<b>Location:</b>	<b>2201 Valley Street</b> <b>(See map on reverse)</b>
<b>Assessor's Parcel Numbers:</b>	<b>008-0658-009-01 &amp; -010-00</b>
<b>Proposal:</b>	Design Review discussion for a proposed development that would include a new 450 tall office building including approximately 760,000 square feet of office.
<b>Applicant:</b>	Denise Pinkston / TMG Partners
<b>Owners:</b>	BA1 2201 Valley LLC & Mash Petroleum
<b>Planning Permits Required:</b>	Regular Design Review for new construction, Major Conditional Use Permit for development exceeding 200,000 square feet and 250 feet in height, and Minor Variances for loading berths (6 required; 3 proposed) and tower dimensional regulations.
<b>General Plan:</b>	Central Business District
<b>Zoning:</b>	CBD-P / Height Area 6
<b>Environmental Determination:</b>	Determination Pending
<b>Historic Status:</b>	Not a historic property
<b>City Council District:</b>	3

# 2201 Valley

## Creative Office Building

## 03 - 28 - 2018 HEARING

## CONTEXT VIEW

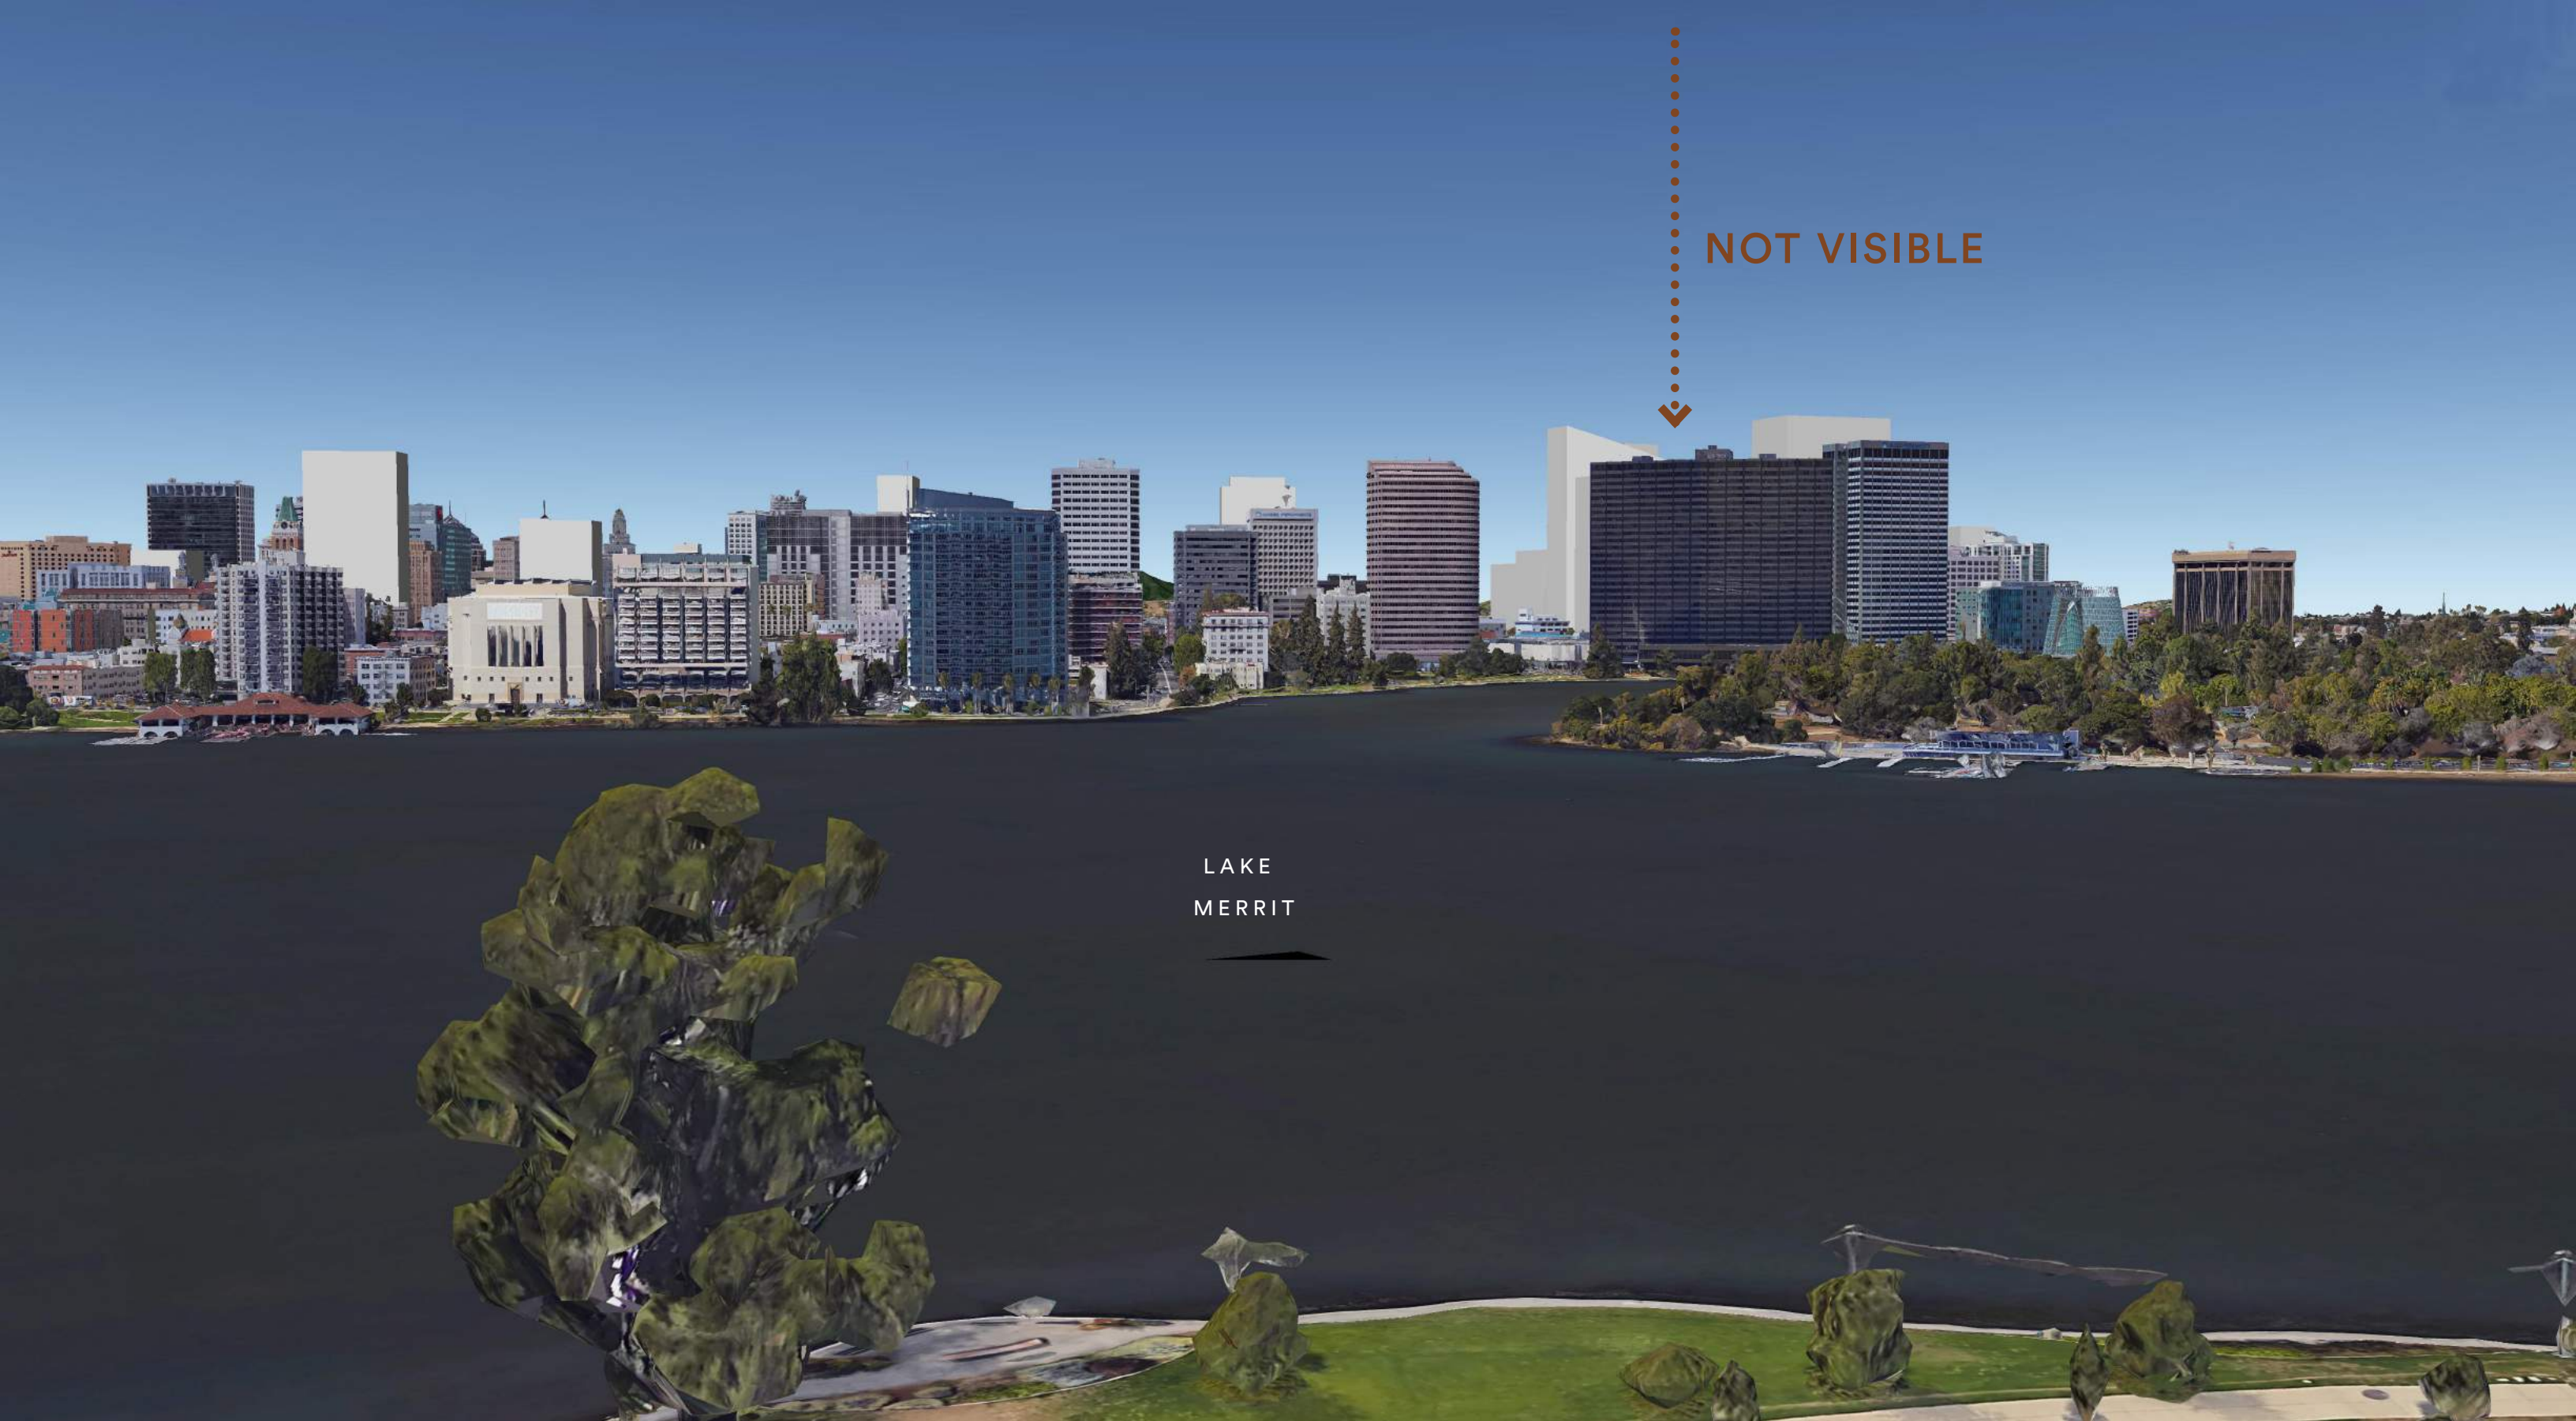
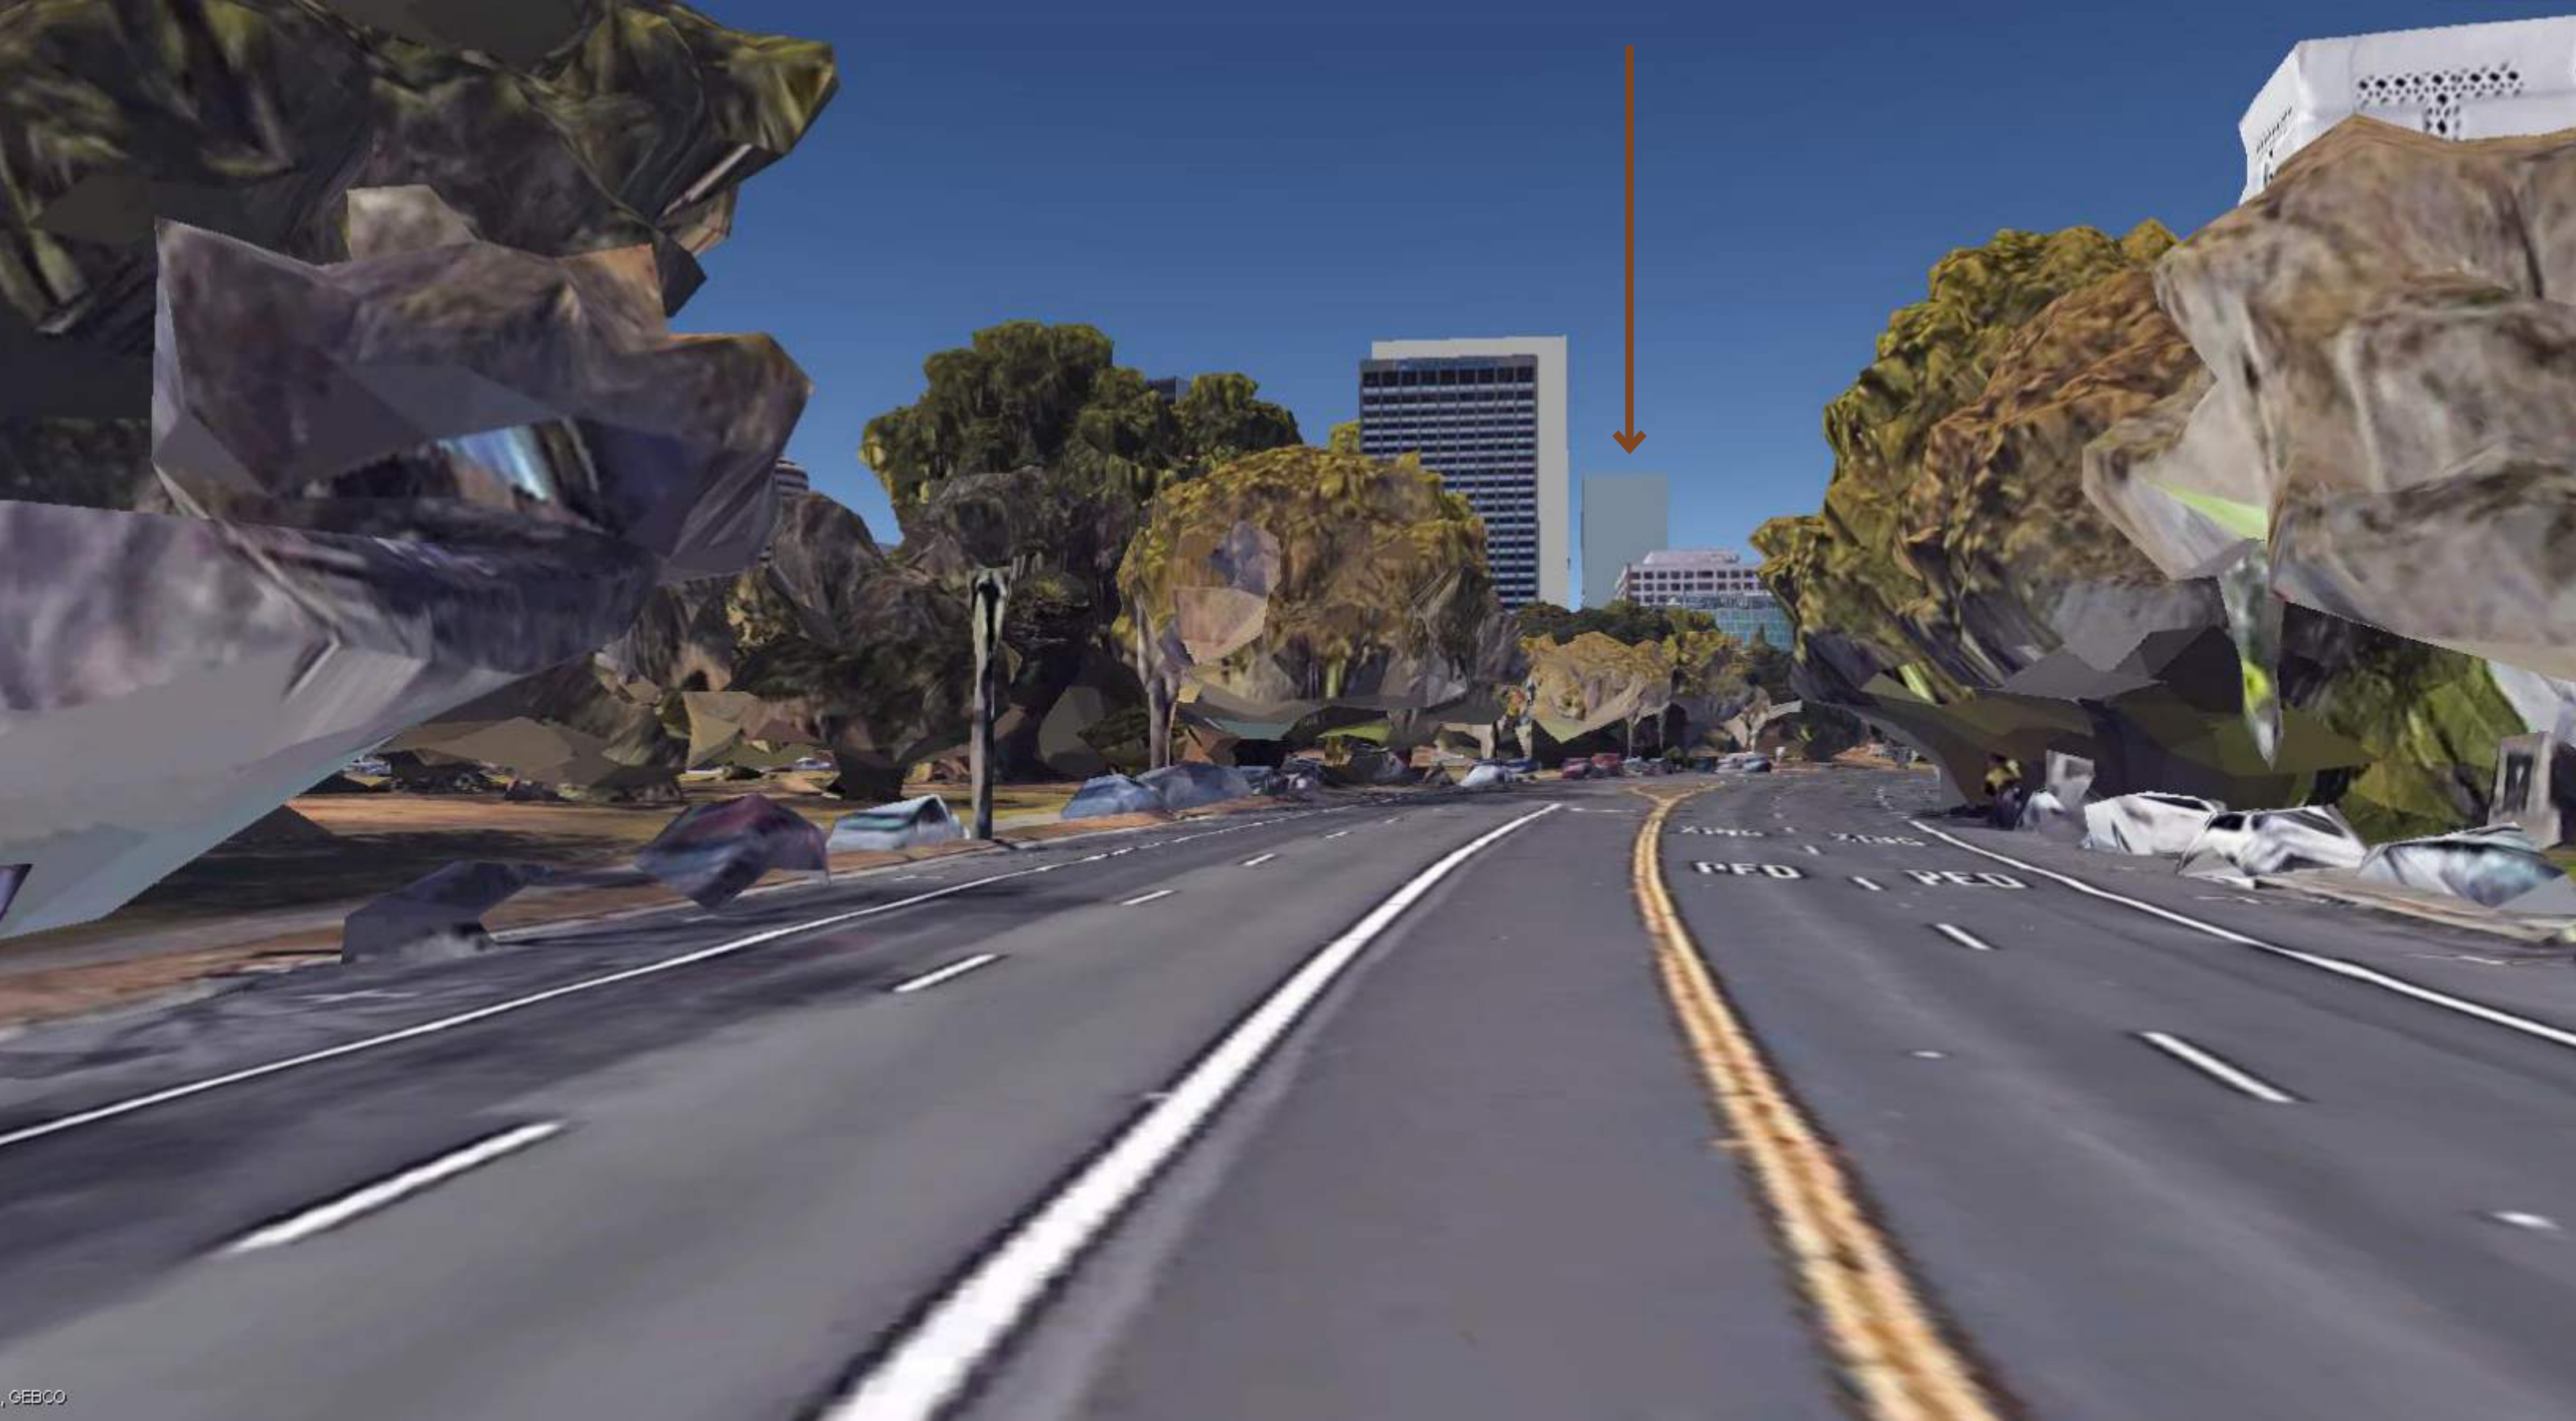
At the prior meeting comments were made about the compatibility of the proposal within the context of the surrounding area as well as the overall skyline view from a distance. The applicant has provided additional images in the plan submittal for consideration and comment.
